Office Action Summary	Application No. 10/711,289	Applicant(s) COULOMBE ET AL.	
	Examiner Marcus Menezes	Art Unit 3677

DETAILED ACTION

Housing

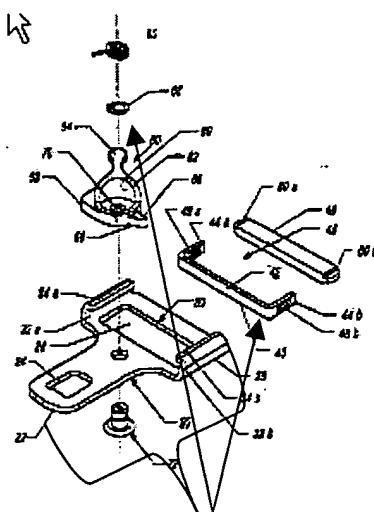
Ashline discloses a quick release buckle comprising a first cam (62); a knurl bar (48); and a first spring (80) engaged with said first cam and said knurl bar. (See Fig. 1 below). Ashline further discloses that said first spring is operatively arranged to apply compressive force against said first cam and said knurl bar. (See Figs. 2-3 and col. 2, lines 60-67). Also, said knurl bar is operatively arranged to grip a belt (90) in response to said compressive force. Moreover, a housing with an integral mounting structure (72) is disclosed; and wherein said housing has bearing walls that the first cam rests, said bearing wall being the top portion of the integral mounting structure (72); and wherein said first cam is operatively arranged to rotate about said mounting structure and wherein said housing further comprises first (20) and second (65) components and said mounting structure is integral to said first component. (See figure below). Additionally, said mounting structure is integral with said second component, is extruded from said housing and is operatively arranged to engage said first and second components.

Furthermore, Ashline discloses that said housing has a first mounting structure that is a protrusion fixedly attached to said housing and where a first cam pivotally mounted on said first mounting structure is operatively arranged to rotate about said first mounting structure.

However, Ashline does not disclose a second cam and a second spring operatively arranged to engage and said second cam and said knurl bar, pivotally mounted rotatably on said housing via a second mounting structure, and operatively arranged to apply a compressive force against said second cam.

On the other hand, it would have been obvious to one having ordinary skill in the art at the time the invention was made to have placed a second cam on the Ashline patent, since it has been held that mere duplication of the essential working parts of a device involves only routine skill in the art.
